ZONING COMMITTEE STAFF REPORT

1. **FILE NAME:** Gerdau Ameristeel US Inc. **FILE #:** 12-103-789
2. **APPLICANT:** Gerdau Ameristeel US Inc. **HEARING DATE:** September 27, 2012
3. **TYPE OF APPLICATION:** CUP w/ variance
4. **LOCATION:** 780 Barge Channel Road, SE of Midwestern Railroad
5. **PIN & LEGAL DESCRIPTION:** 092822340019, see file for complete legal description
6. **PLANNING DISTRICT:** 3 **PRESENT ZONING:** I2, FF
7. **ZONING CODE REFERENCE:** §§65.846, 68.402(c)(7), 72.74, 72.32, 72.75, 61.501; 61.601; 61.202(b)
8. **STAFF REPORT DATE:** September 18, 2012 **BY:** Josh Williams
9. **DATE RECEIVED:** September 6, 2012 **60 DAY DEADLINE FOR ACTION:** November 5, 2012
-

- A. **PURPOSE:** Conditional use permits for outdoor recycling processing center and for use of a method other than fill to elevate a structure above the regulatory flood protection elevation and variances for site access more than two feet below RFPE and rehabilitation slopes greater than 18%.

Sheet No: C8-1

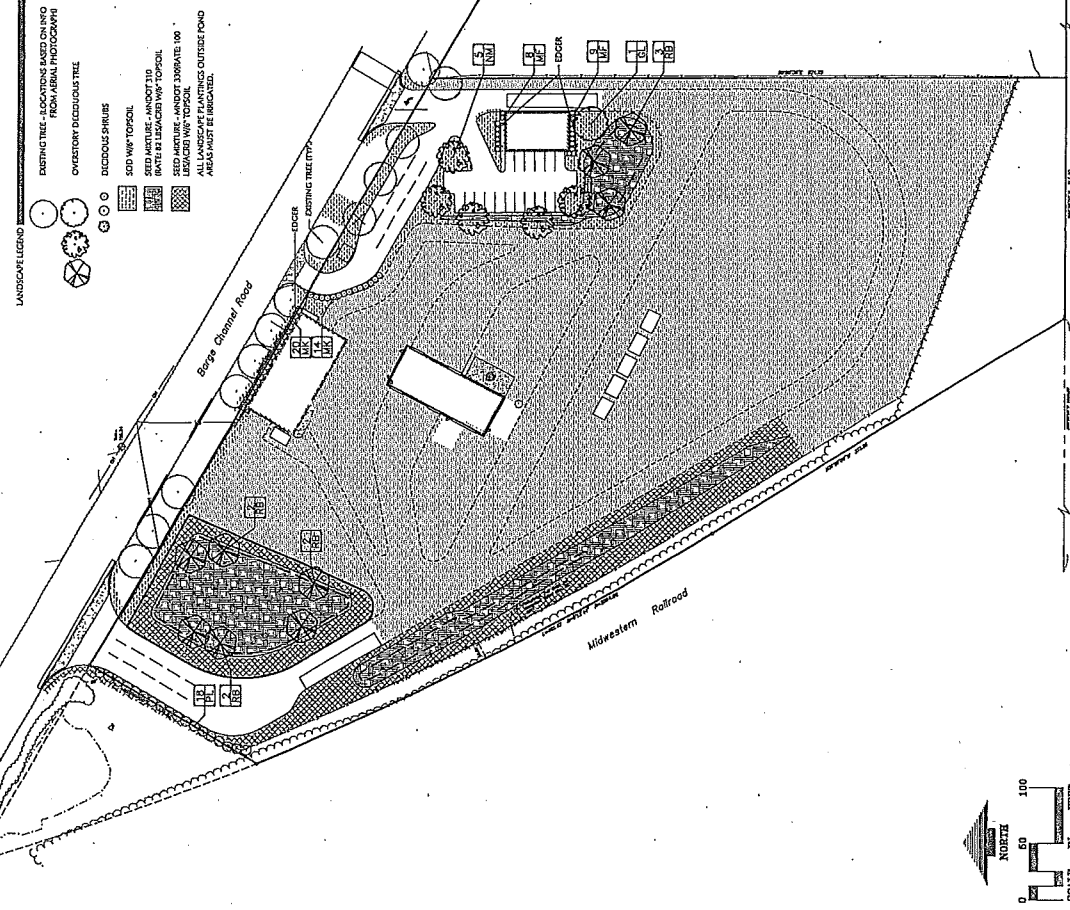
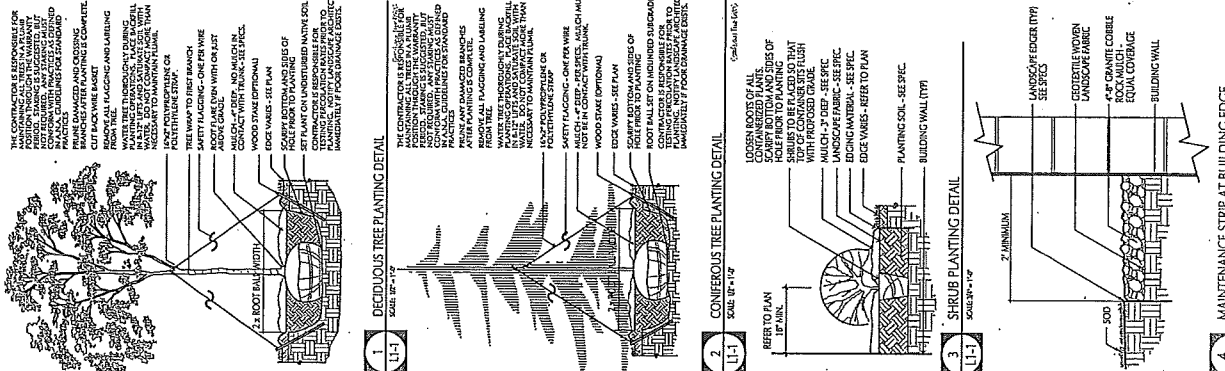
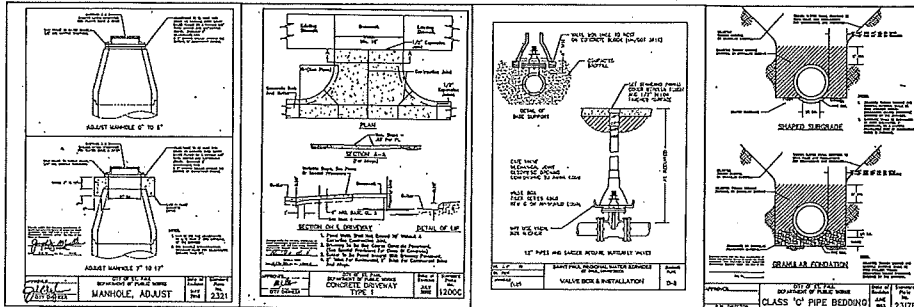
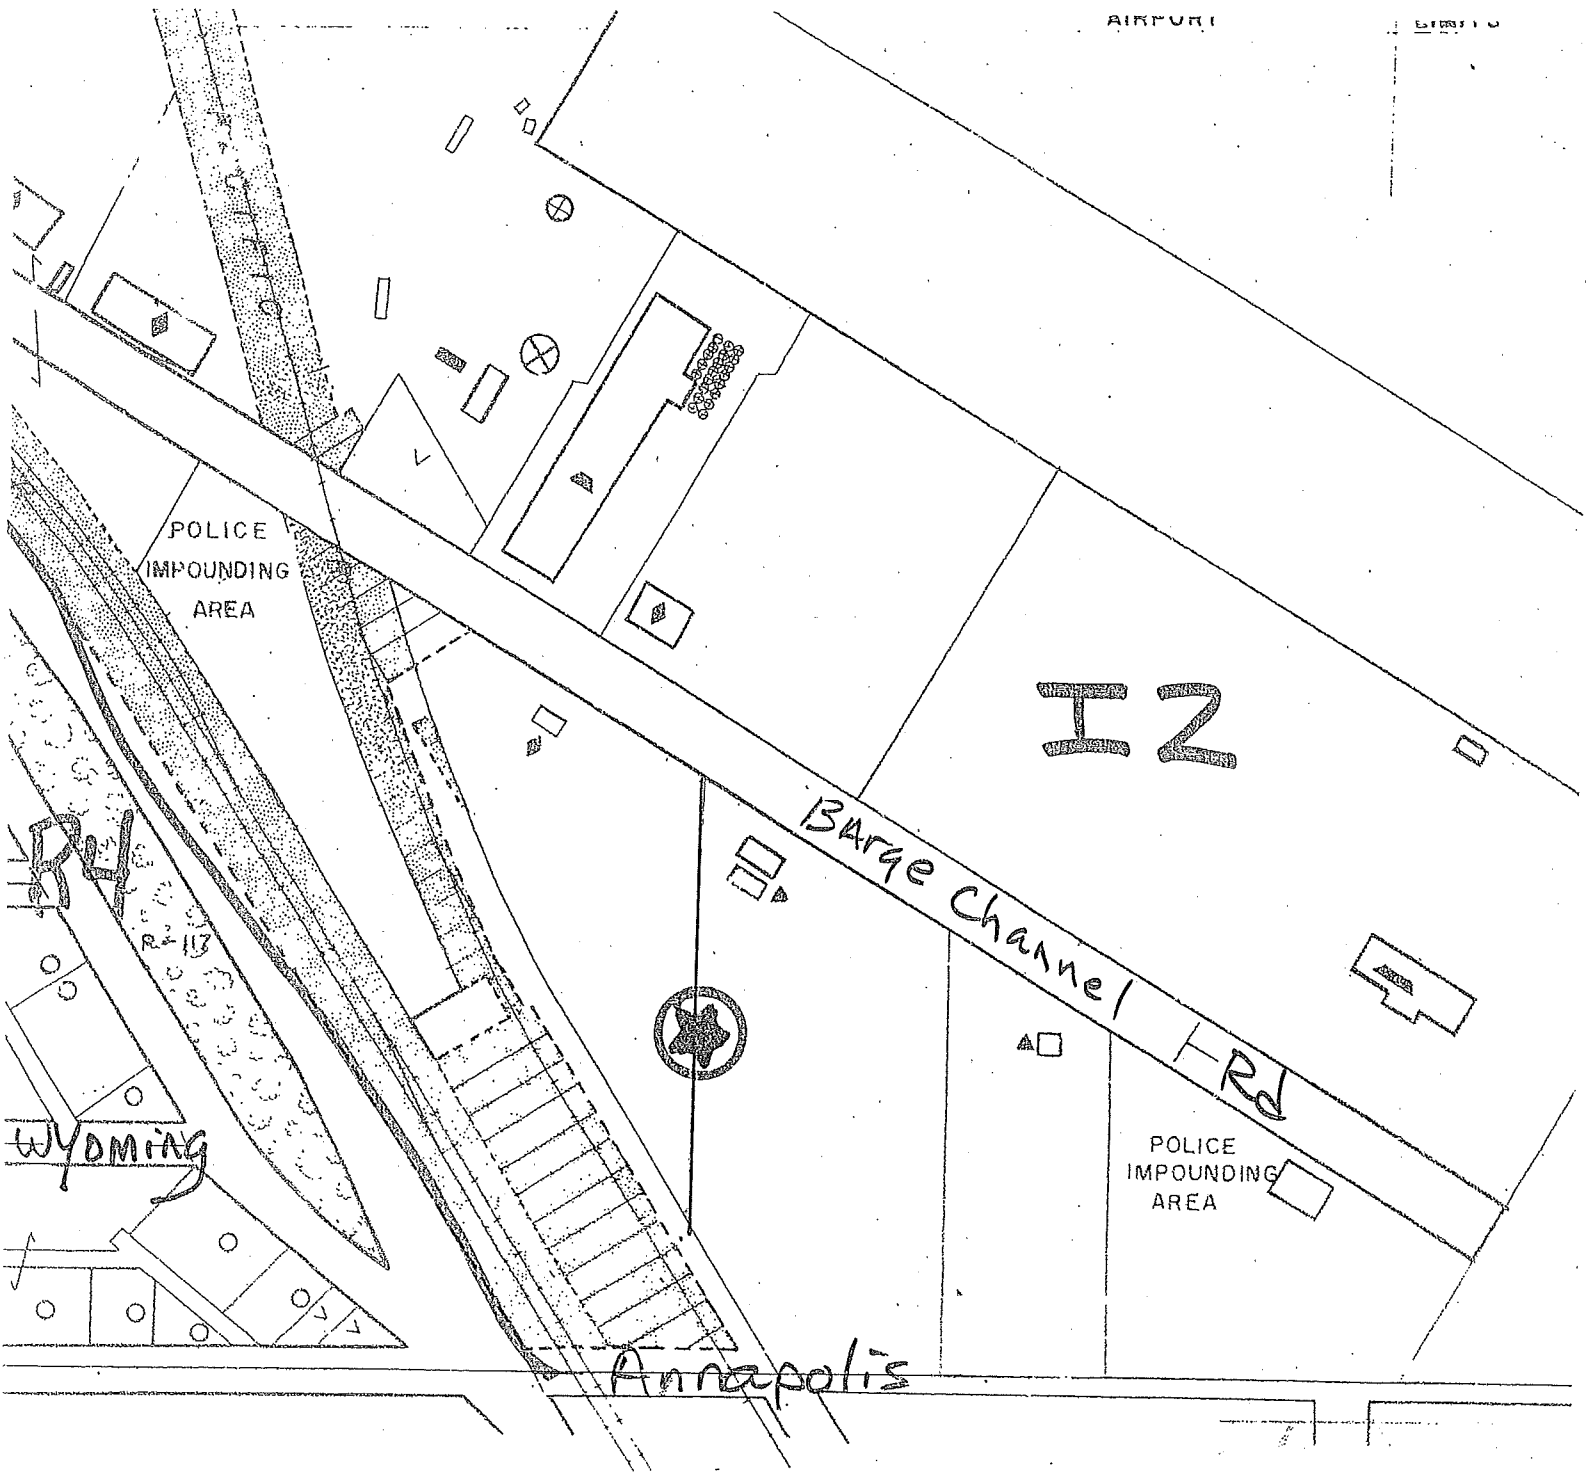
A 16' wide Pedestrian Trail Easement has been provided along the southwest edge of the site. Ellen Stewart of Parks said the site plan looks OK if the existing grades in the easement area are not changed by the project and a visual screen is provided to separate the trail area from the rest of the site. The plan calls for an 8' high chain link fence with "privacy fabric. Staff asked you to provide a photo or more information of the privacy fabric.
